Process Sheet

Customer : CU-DAR001 Dart Helicopters Services Drawing Name : HELI UTILITY BASKET LH/RH 350/355
 Job Number : 34280
 Estimate Number : 10208
 P.O. Number : *N/A* Part Number : D350607043
 This Issue : 8/28/2007 S.O. No. : *N/A* Drawing Number : D350-607 REV F P7-9
 Prsht Rev. : NC Project Number : *N/A*
 First Issue : *N/A* Type : LARGE FAB ASSY Drawing Revision : F
 Previous Run : 34279 Material : *N/A*
 Due Date : 9/21/2007 Qty: 1 Um: Each
 Written By : *JA*
 Checked & Approved By : *JA 07.08.28*
 Comment : Est Rev: E as Per DSI9318 06-01-24 JLM

DESIGN <i>CP</i>	DRAWN BY <i>CP</i>	DART AEROSPACE LTD HAWKESBURY, ONTARIO, CANADA	
CHECKED <i>[Signature]</i>	APPROVED <i>[Signature]</i>	DRAWING NO. DSI 9318	REV. A SHEET 1 OF 1
DATE 06.01.06		TITLE WASHER ADDITION	SCALE NTS
A	06.01.06	NEW ISSUE

DART SERVICE INSTRUCTION

Figure 5- Basket Replacement Parts
(D350-607-043 Heli-Utility-Basket™)

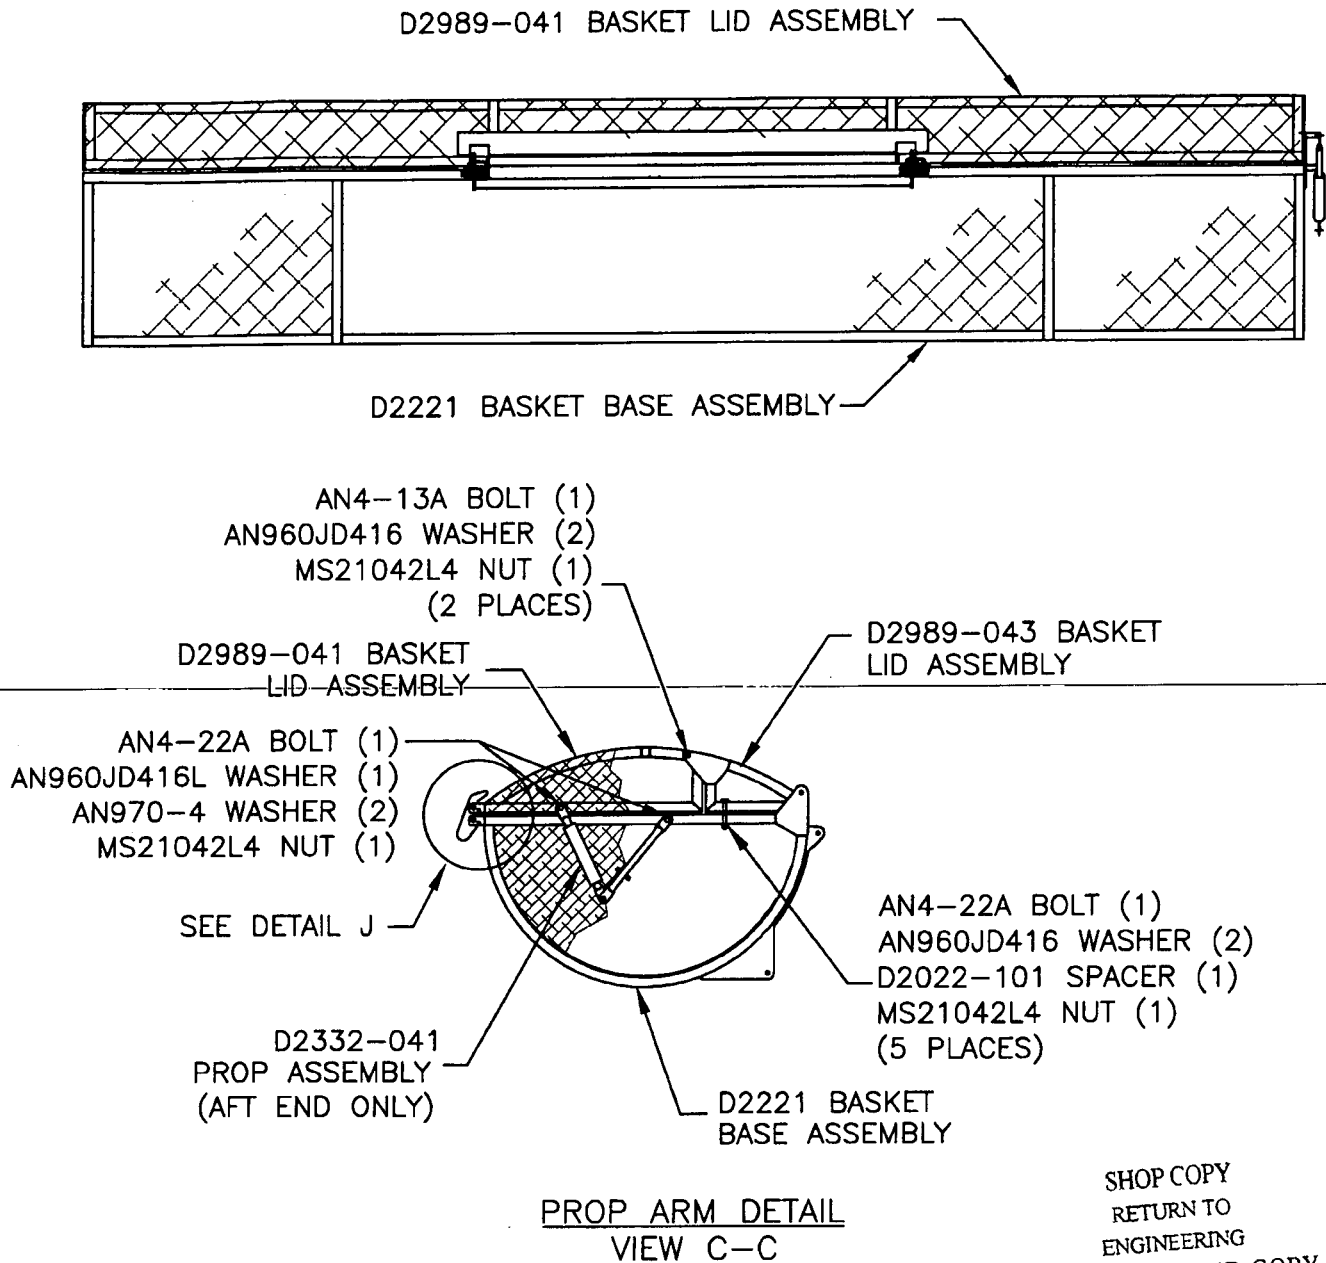
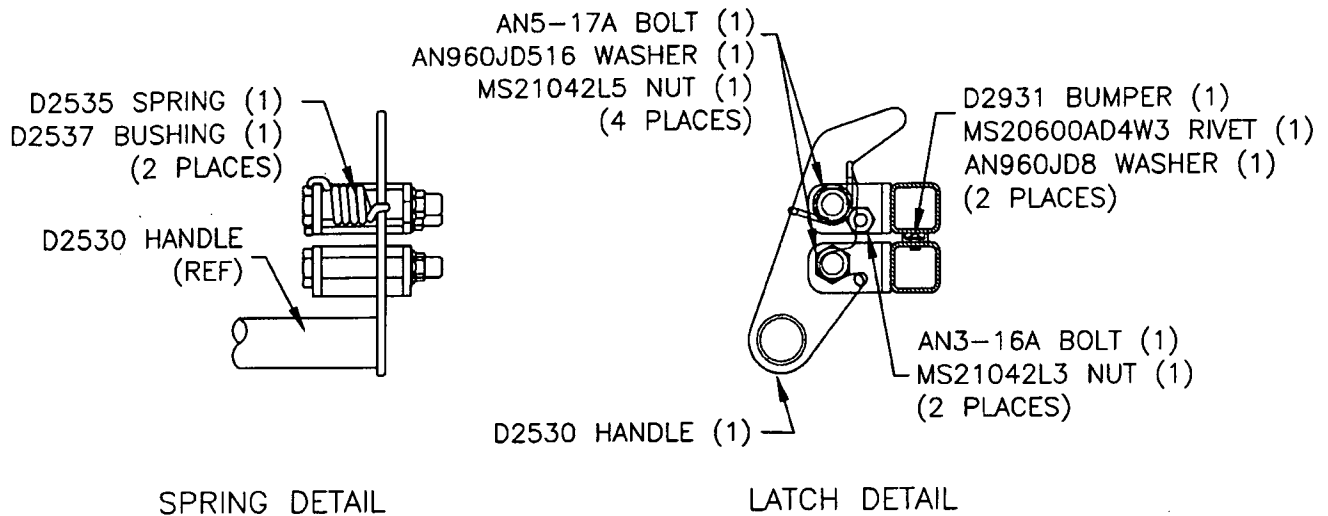
The corrected bolt stackup from Figure 5 of installation instructions D350-607 Rev. F is given below:

AN4-13A BOLT (1)
AN960JD416 WASHER (1)
HINGE PLATE (REF)
NAS1515H4 WASHER (1)
BASKET FRAME (REF)
AN960JD416 WASHER (1)
MS21042L4 NUT (1)
(2 PLACES)

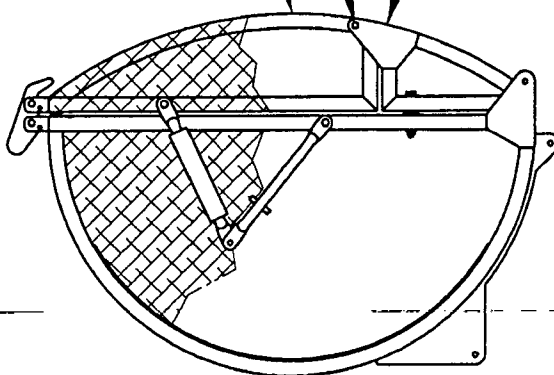
To reduce the possibility of damaging the finish, a **NAS1515H4** washer (2 places) has been added between the hinge plate and basket frame on the **D350-607-043/-047 Heli-Utility-Basket**.
